SUPER LAW GROUP, LLC

January 27, 2016

Re: **Comments of Sierra Club Regarding Renewal of
Schiller Station NPDES Permit No. NH0001473**

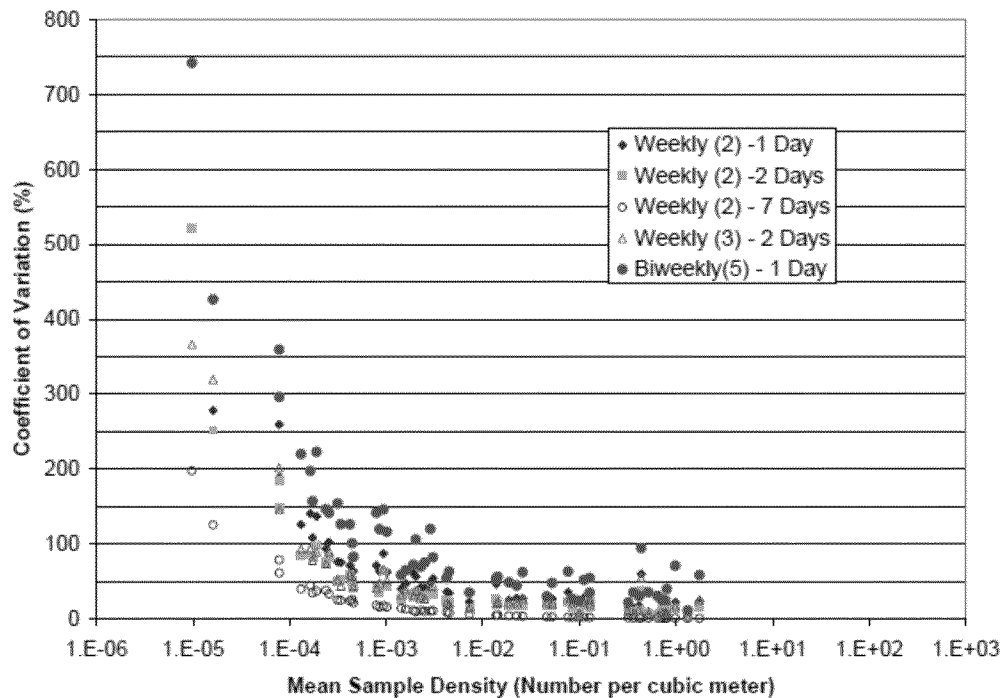
Variability in entrainment rates increases when entrainment rates are high compared to when they are low. Thus, it would make sense to sample at a higher frequency during periods of high entrainment to reduce the uncertainty when estimating annual entrainment. In theory, this was partly addressed at Schiller except for the months of May and September which were periods when significant entrainment of ichthyoplankton and crustaceans occurred (Tables 2.4 and 2.6). As mentioned above, sampling occurred one day per week at the CWIS during periods of expected higher entrainment and during times of expected lower entrainment, sampling occurred on a biweekly basis. However, as shown below in Figure 3.1, entrainment sampling frequency strongly affects the precision of annual entrainment estimates. For biweekly sampling, the coefficient of variation (CV) of annual entrainment estimates ranged from about 50% at the highest densities to 750% at the lowest densities. For sampling one day per week (Scenario 2), CV ranged from over 250% at the lowest densities to less than 50% at the highest densities. Sampling twice per week on random days (Scenario 2) decreased the CV and sampling 7 days a week (Scenario 2) decreased the CV even further (although sampling every day is cost prohibitive). In Scenario 3 where sampling was also conducted twice per week but on consecutive days, the CV was higher than when weekly sampling was conducted on random days (EPRI 2005a). In all cases presented in Figure 3.1, there were four events per day with 100 m³ of water per sample which is similar to that which was used at Schiller (Normandeau 2008). A more robust sampling design of one or more samples/week especially during periods of high entrainment is recommended for verification monitoring following BTA selection.

Figure 3.3 Mean Larval Fish Density (#/100 m³ sampled) by Week (all Life Stages Pooled) for Entrainment Samples Collected at Schiller Station for the Period of August 31, 2006 to September 27, 2007

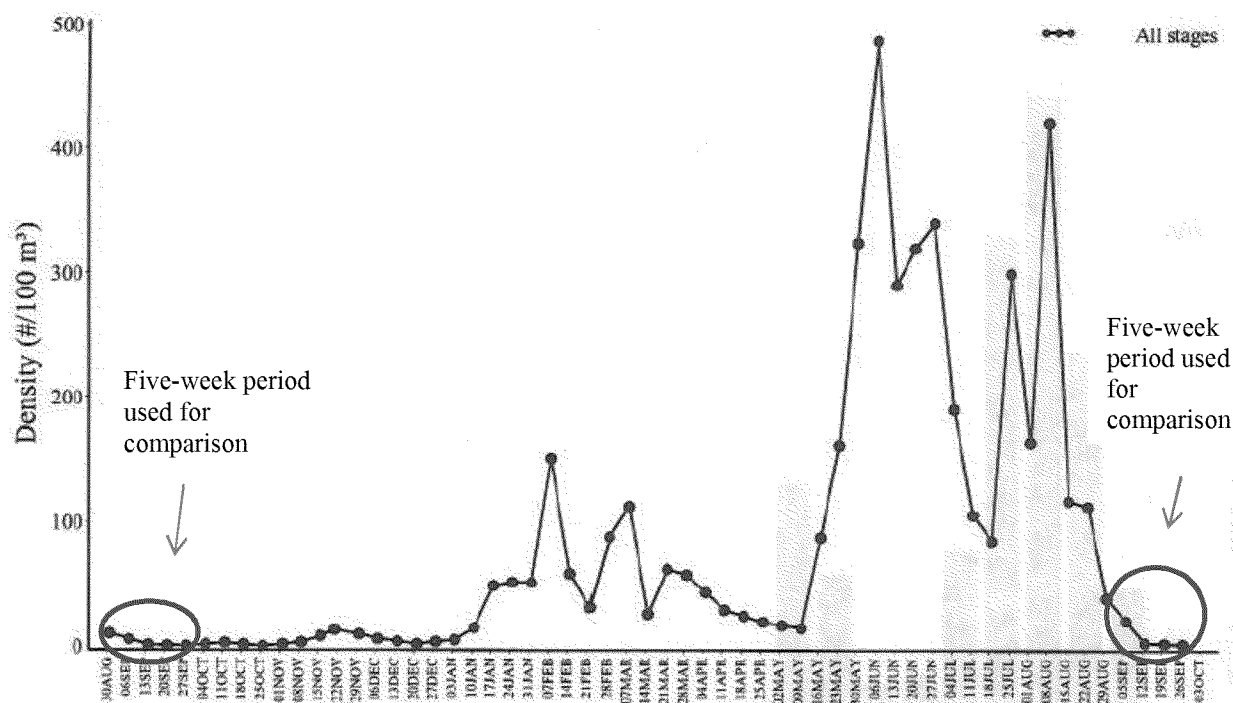
- No Seasonal Data: Data only presented over a five (5) week period and no seasonal component.
- Limited Data: The year- to-year comparisons are based only on five-(5) data points for each over the 5 week period from August 31-September 28, 2006 and August 30-September 27, 2007. This period (5 weeks) represents less than 15% of the entire year sampled. It is important to note that these samples were also based on biweekly samples, not weekly, which was done during the key entrainment periods. Entrainment sampling occurred weekly during periods of expected higher entrainment (13 weeks in June-August 2007 and 13 weeks in January-Mach 2007). EPRI (2005a) reviewed entrainment data at Indian Point which shows that sampling frequency strongly affects the precision of annual entrainment estimates. For biweekly sampling, the coefficient of variation (CV) of annual entrainment estimates ranged from about 50% at the highest densities to 750% at the lowest densities. Comparisons used at Schiller were at the lower densities of ichthyoplankton abundance (see Figures 3.3 and 3.4). For this reason, it is believed that these comparisons are not considered statistically valid for an entire year of entrainment.

Figure 3.5 Mean Fish Density (#/million gallons) by Week for Impingement Samples Collected at Schiller (Units 4, 5, and 6 combined) for the period August 31, 2006 to September 27, 2007

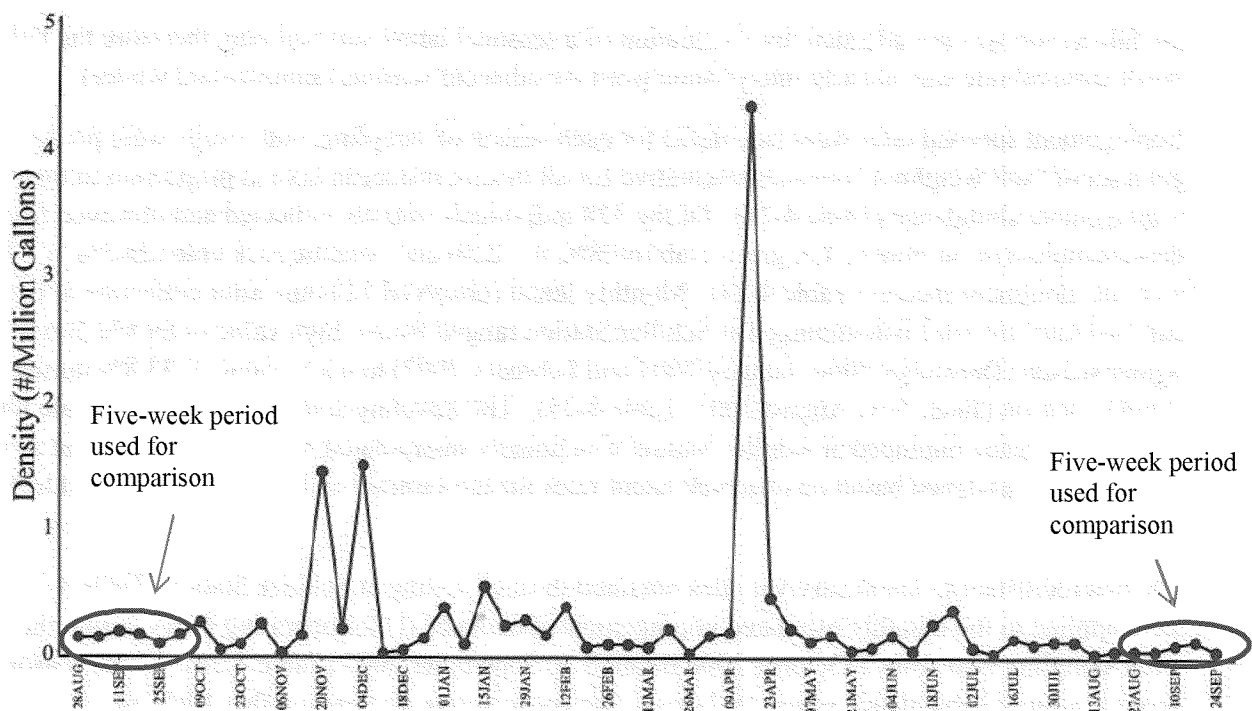
- No Seasonal Data: Data only presented over a five (5) week period for 2006 (August 31 to September 28) and 2007 (August 30 to September 27) and no seasonal component.
- Key Impingement Periods. The key impingement period for fish impingement is clearly not during end of August to end of September. The adjusted fish densities impinged (see Table 2.13) represent less than 4% of total annual impingement for September 2007. Figure 4.1 of Normandeau (2008) shows the relatively low densities for comparison for the sampling month comparison for which are clearly not representative of higher periods of impingement (see Figure 3.5). The same occurs for macrocrustacea.
- Comparisons cannot be extrapolated for an entire year since there is no seasonal component and at a period when densities are naturally low.
